BOA228-Review #1 - 5/25/22 Planning
Please address the following items on your site plan:

PLOT PLAN
(THIS IS NOT A PROPERTY SURVEY)

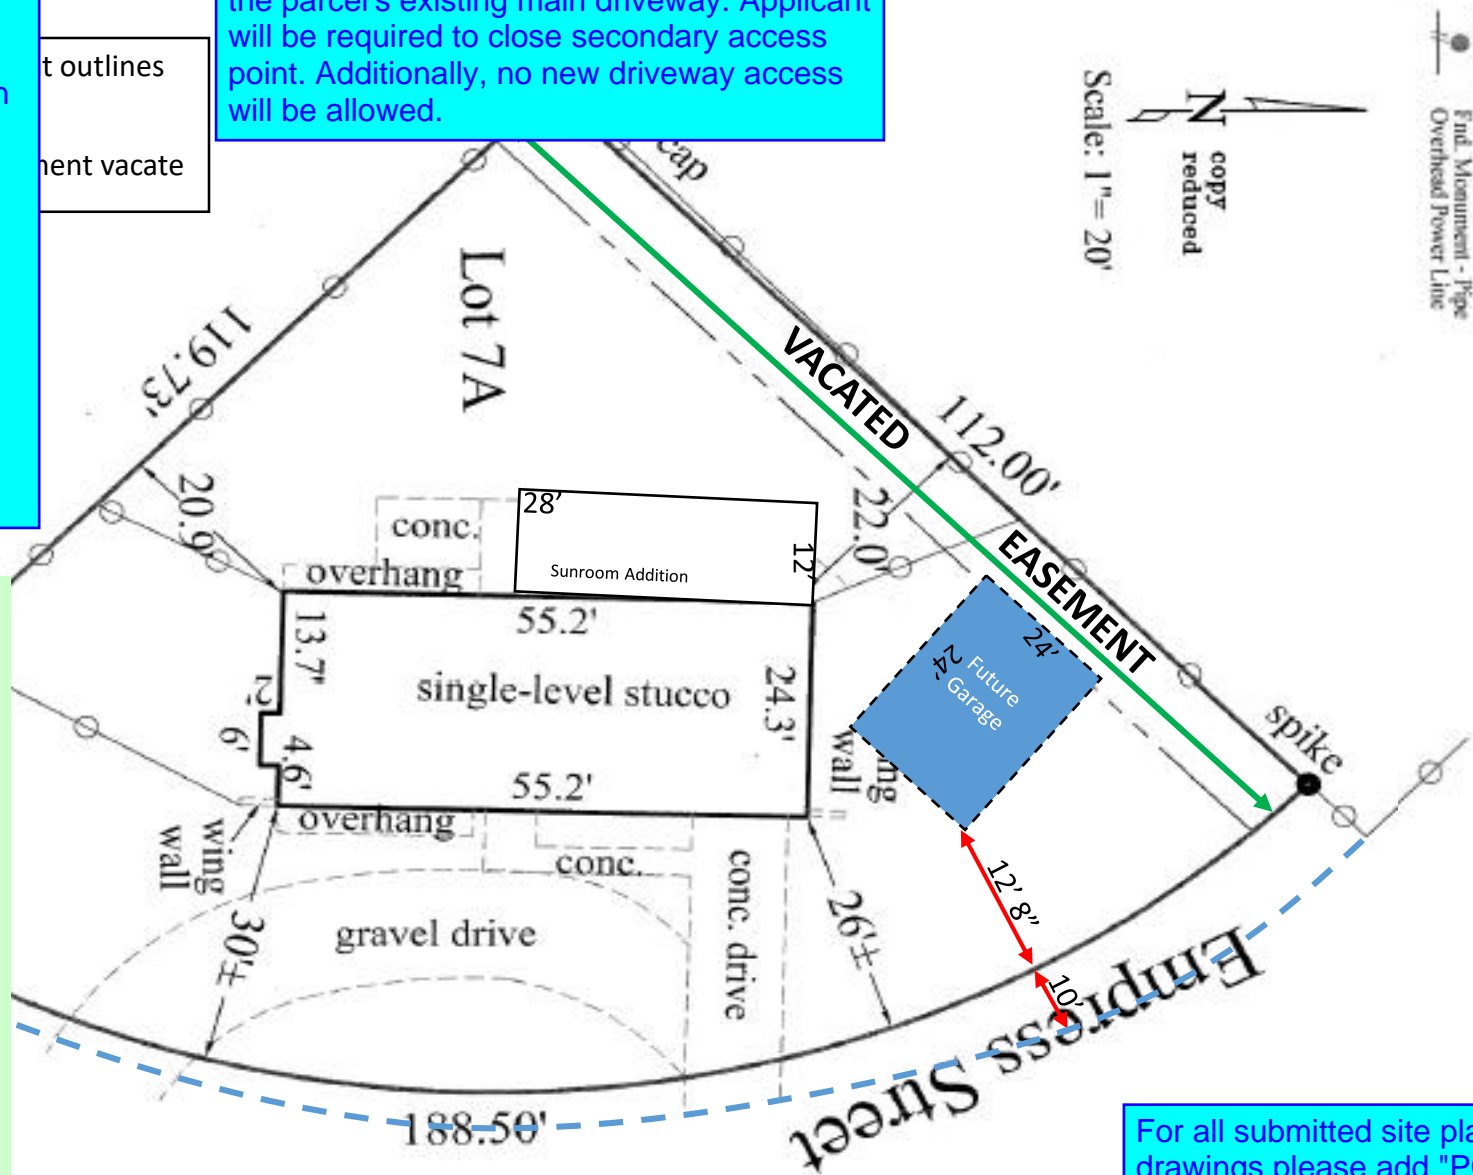
Per El Paso County Engineering Criteria Manual Chapter 2.4.1.B "accesses shall be separated by a distance equal to the entering sight distance values in Table 2-35." Per Table 2-35 for a two lane roadway with a posted speed limit of 25mph access shall be spaced a minimum of 250 feet for passenger cars.

- The parcel does not meet the criteria above for multiple access points. No new driveway access will be allowed for the proposed structure.

- Please show the proposed structure's driveway; proposed driveway should connect to existing driveway.

Please apply for a driveway access permit for the parcel's existing main driveway. Applicant will be required to close secondary access point. Additionally, no new driveway access will be allowed.

- Brief description of request
- The setback request on this sheet should match the letter of intent.
- Include setback requirements and what is being proposed. Include the side setback.
- Include proposed driveway location
- Include distance from the house to the proposed garage
- draw the 24'x24' garage to scale - it is a rectangle
- include the location and width of all sidewalks
- Include height of the proposed garage
- if applicable, indicate the location of existing and proposed water and wastewater infrastructure, including well(s) and septic system(s)
- if applicable, location of all no-build areas, floodplain(s), and drainage facilities
- Note the existing/proposed land use, parcel size, and zoning

For all submitted site plan drawings please add "PCD File No. BOA-22-008" to the bottom right hand corner.
